ภาคผนวก จ

สำเนาเอกสารเกี่ยวกับการจัดการคุณภาพน้ำ

RAW WATER & DEMINERALIZED WATER SYSTEM FLOW DIAGRAM

BLCP Power Limited BLCP Power Plant Project	COMMENT RESOLUTION SHEET	BLCP Letter Ref No. TH041624MM182306IRN Date: 28 July 2004
BLCP Dwg No : M1-MF-HR-PP-00082 Rev No. 0 MCP Dwg. No. : 97000-2262-18	MCP Dwg. Title : Flue Gas Desulfurization System Design Manual MCP Transmittal No. : MAP-MHIN-BLCP-T-00749 Issue Date: : 25 June 2004	Sheet No (1/9)

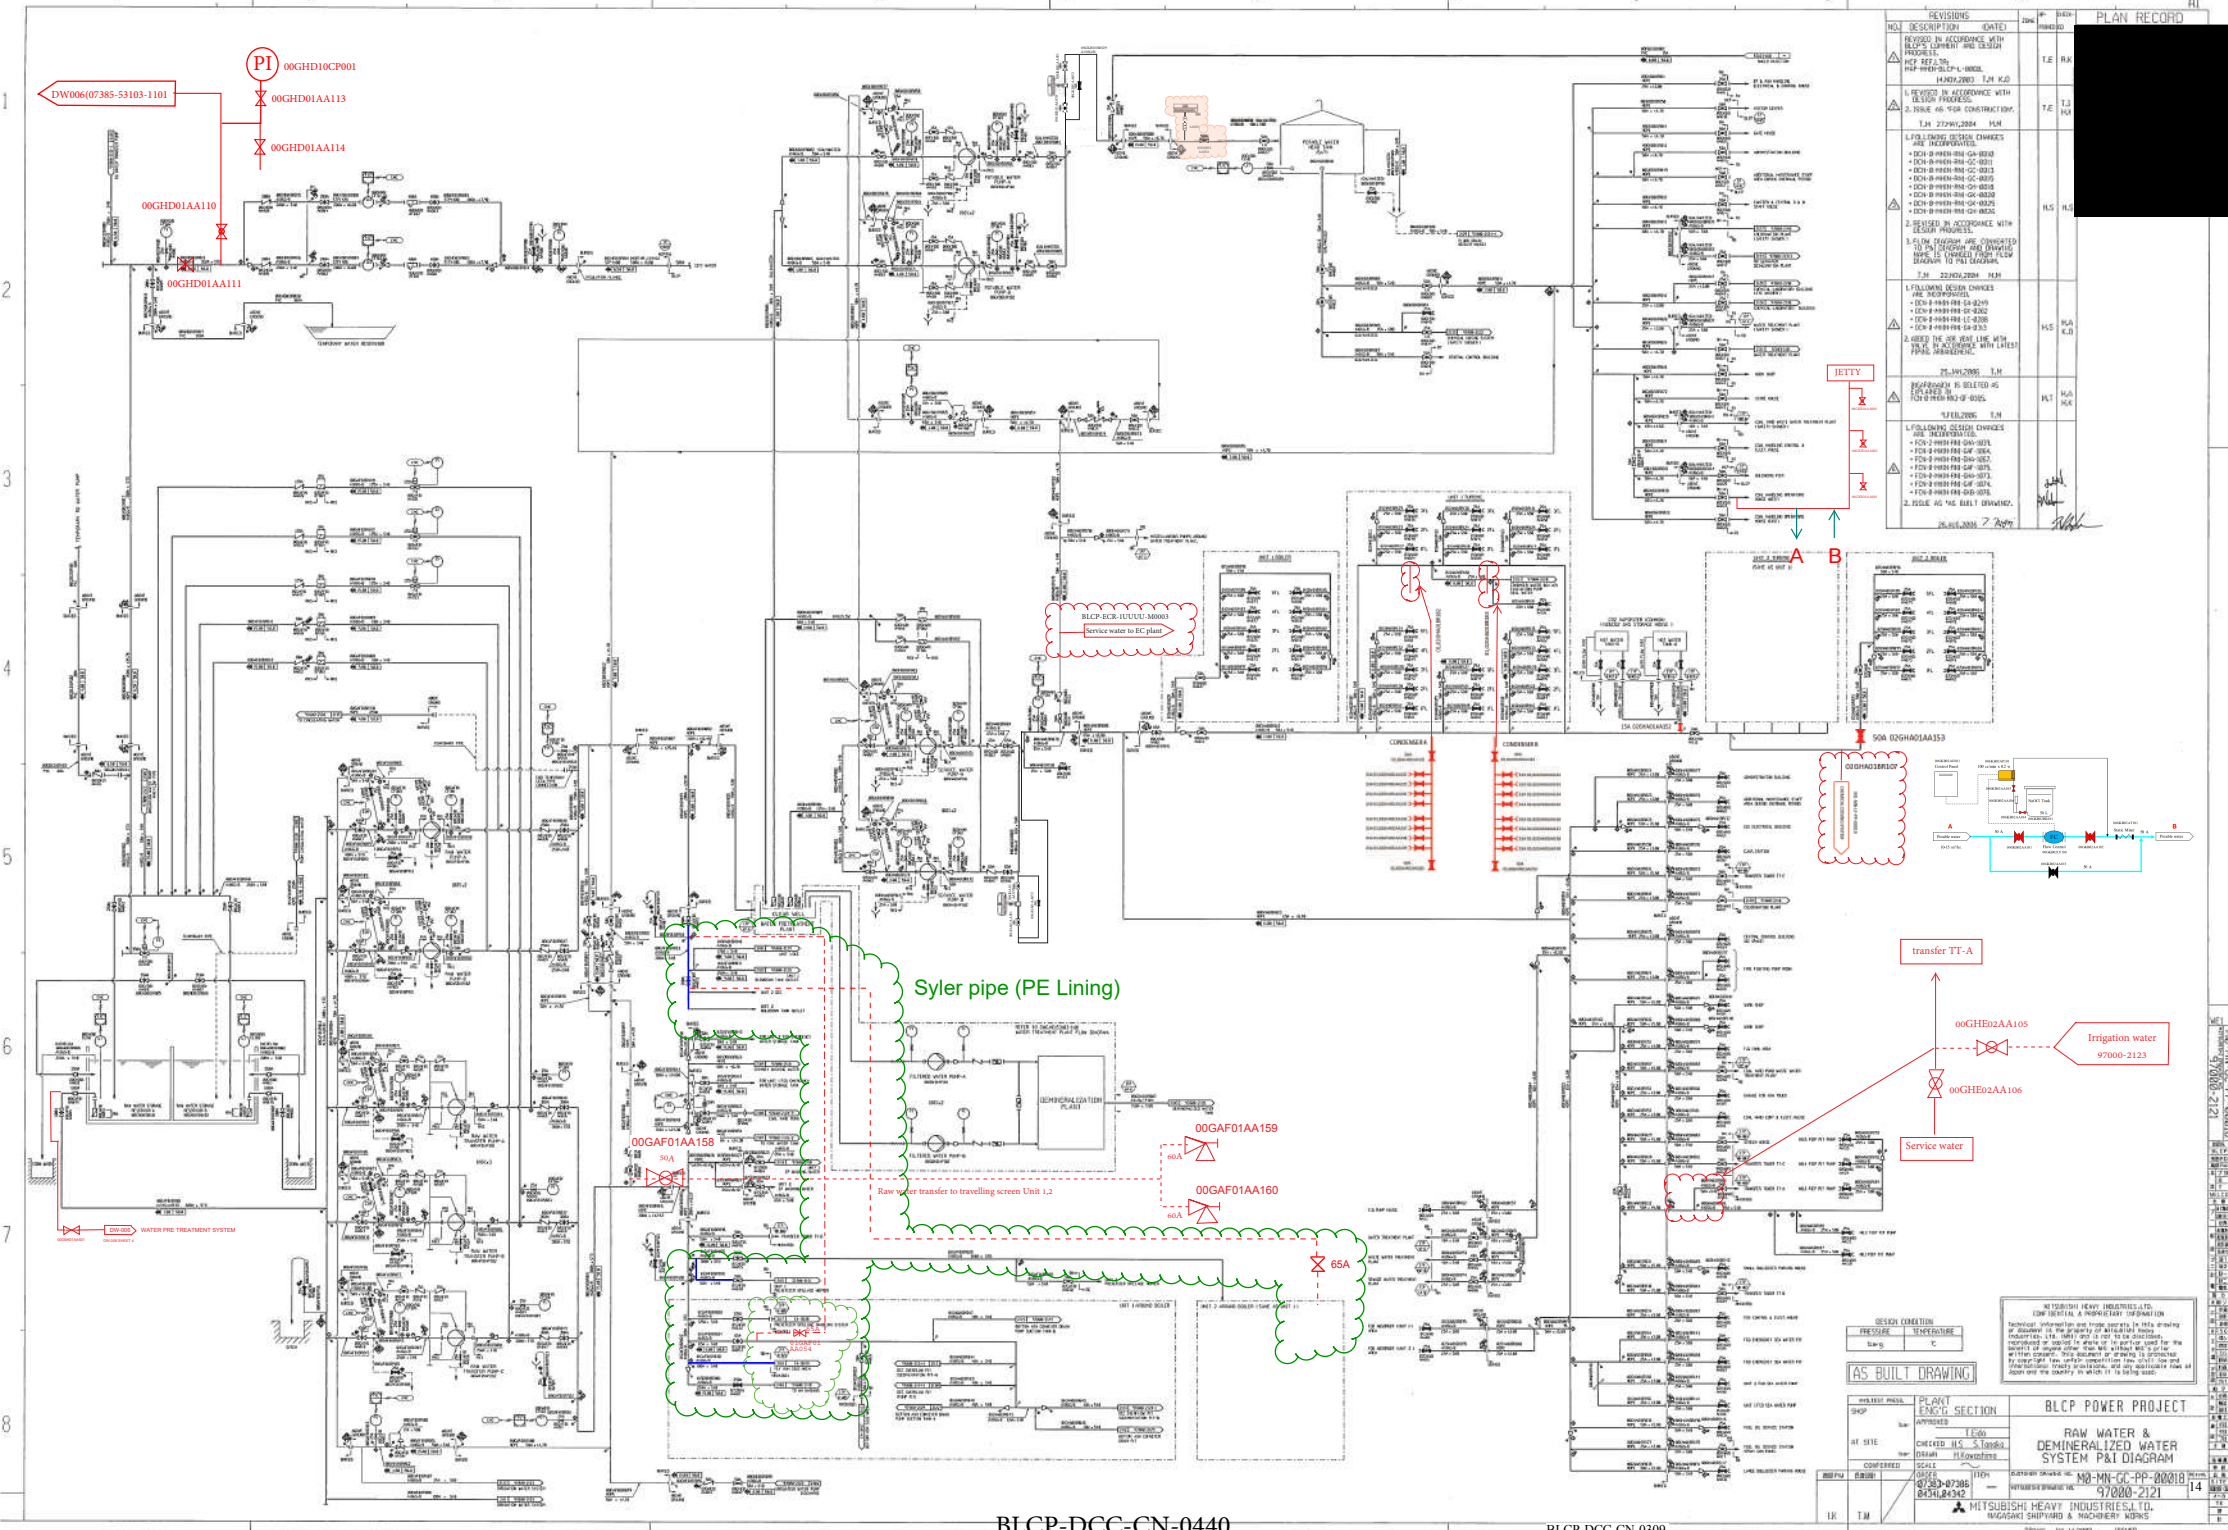
REVISED	DESCRIPTION	AMENDMENT	REMARK
14	**Revised according to Plant Modification #** PI# 1179. The Treated waste water Zero dischrage project. To install new raw water supply from raw water metering station to Clarifier (BLCP-DCC-CN-0309)	**13-Jun-16**	
15	Plant Modification No. 1627 Addition a new NaOCl Injection Skid for control Free residual Chlorine in Potable water for supply to Jetty Area to improvement FRC content in Potable water at Jetty around 0.2 – 0.5 ppm. (BLCP-DCC-CN-0437)	**4-Oct-22**	
16	Plant Modification No. 1438 and 1528: Project replace some portion of Raw water pipe header unit 1 and unit 2 from carbon steel pipeline to Syler pipeline. The purpose of this modification is to reduce posibility of pipe leakage from internal corrosion which affect to plant efficiency in case of could not stop leakage. This case is relate to PI-1217 which make leak and performamce of BATC belt cleaning system drop. BLCP-DCC-CN-0440	5-Oct-22

(M0-MN-GN-PP-01510 (53106-1101)

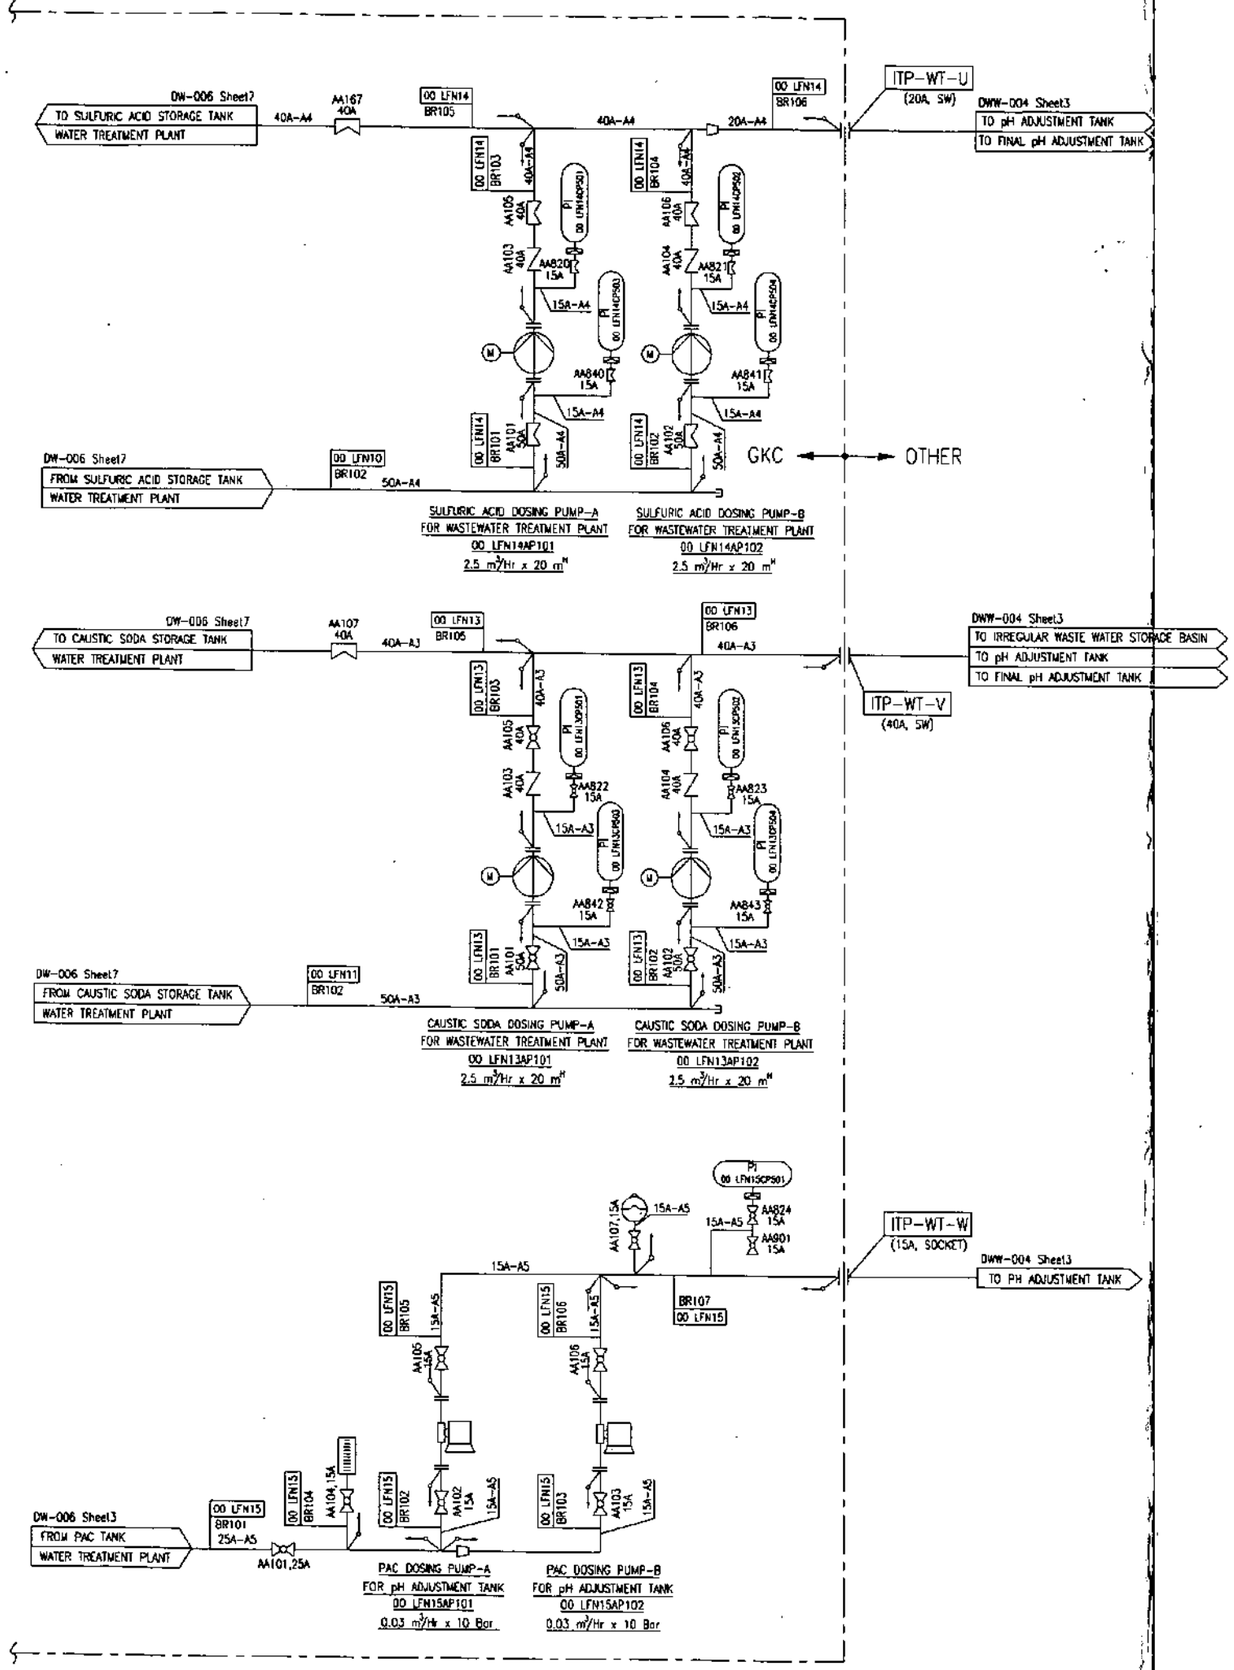
REVISED	DESCRIPTION	AMENDMENT ISSUE DATE	REMARK
4	**Revised according to Plant Modification #** No.437 (Addition of Sludge level transmitter) **Revised sheets No.:** 1. Revised sheet No.4 (DWW-004)	- 3 APR 2009	
5	Revised according to Plant Modification No. 661 (Addition new manual valve at dehydrator sludge inlet pipe.) (Refer Change request # BLCP-DCC-CN-0116) Revised sheet No. 1. Sheet No. DWW-004	3 Feb. 2010	
6	Revised according to Plant Modification No. 832 and wo#3713552. Modification addition new pressure control valve and maunal isolate valve for pressure control valve . (Refer Change request # BLCP-DCC-CN-0204) Revised sheet No. 1. Sheet No. DWW-004	8 Feb. 2012	
7	Revised according to Plant Modification No. 387 and WO# 3871927. Additional new line and isolation valve to transfer waste water between regular and irregular basin. (Refer Change request # BLCP-DCC-CN-0261) Revised sheet No. 1. Sheet No. DWW-004 (sheet No. 2)	11 Apr. 2013

Attachment - 4 sheett 2 of 4

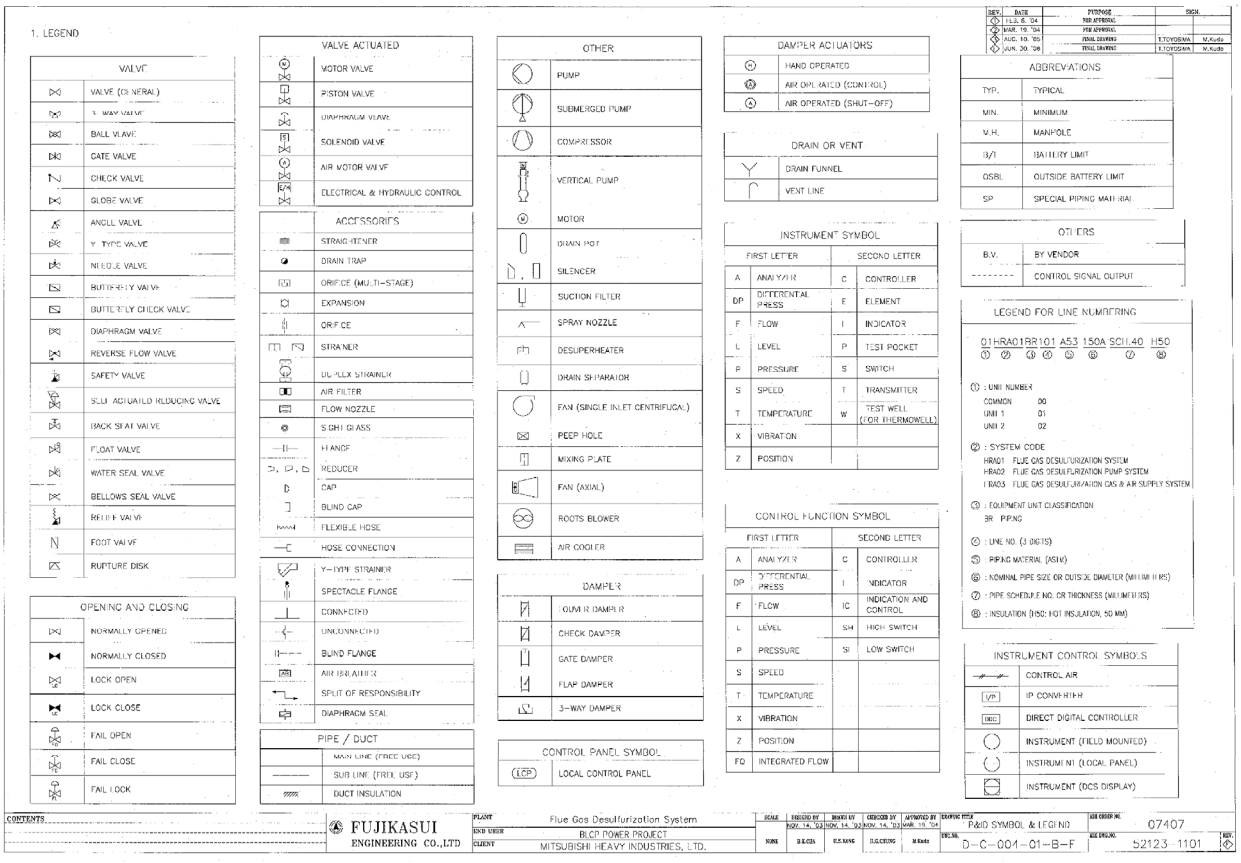
REVISED	DESCRIPTION	AMENDMENT ISSUE DATE	REMARK
2	Revised according to PI#828 & 576. No. 828 & 576. Installation FGD lower distributor inlet strainer system. (Refer Change request # BLCP-DCC-CN-0245) Revised sheet : 1. 1. Dwg. No. D-1-005-01-B-F Attachment 4 sheet 2/4	10-Aug.-12

Attachment – 10 (Sheet 6 of 6)

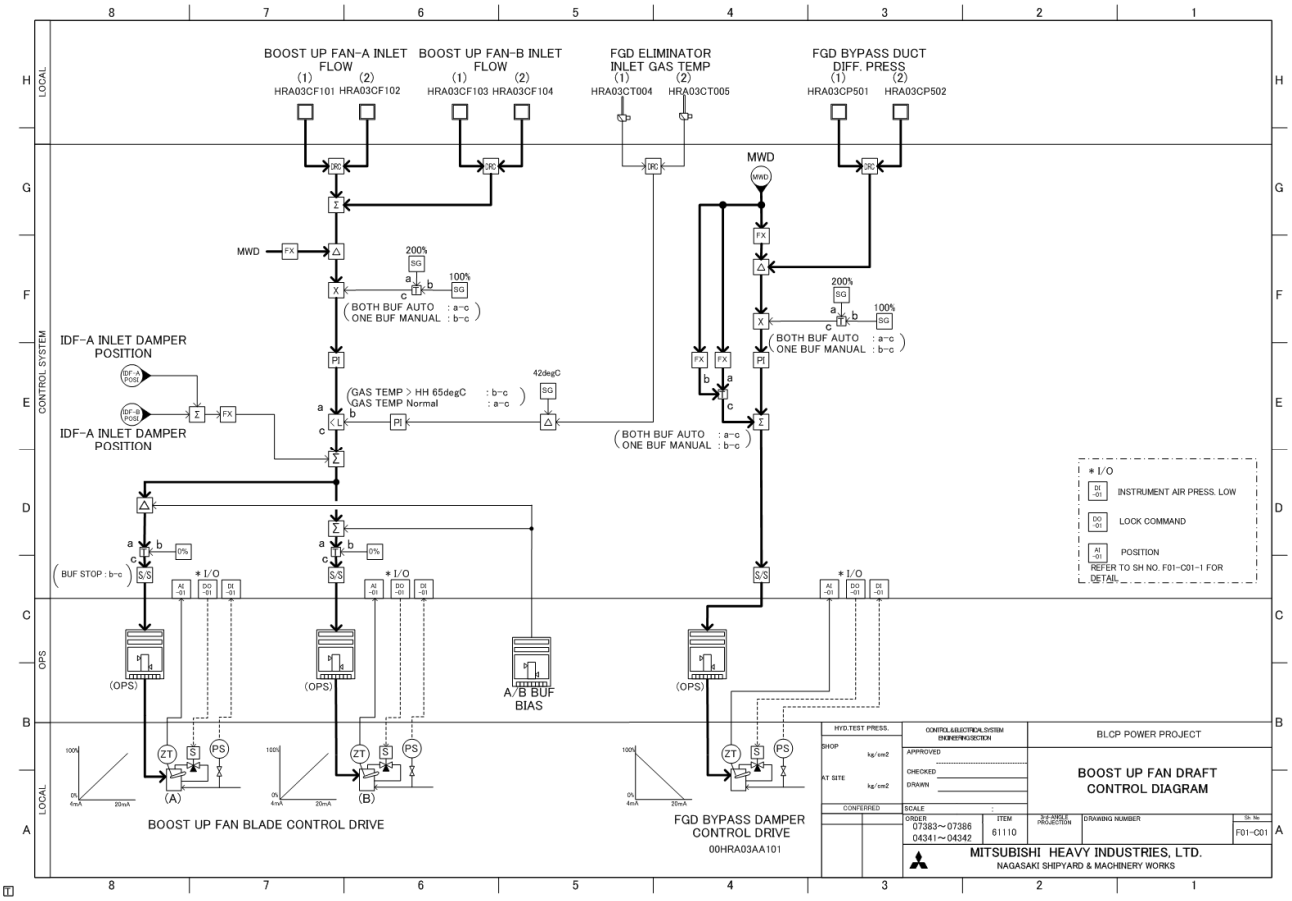
3.	*4.2 FGD Bypass Damper Control, page 24* – "A differential pressure transmitter measures . . . . . will be function of MW demand" please give more explanation for this clause.	As shown in the control diagram attachment - 10 - (6/6), [FGD bypass damper opening demand] = [demand based on MW demand] — [bias based on differential pressure across the FGD bypass damper] When the differential pressure across the FGD bypass damper is positive, FGD bypass damper opening demand is equal to the demand based on MW demand. However, only when the differential pressure turns negative pressure, secondary PI controller generates the bias which is subtracted from the demand based on MW demand so that differential pressure across the FGD bypass damper is positive.
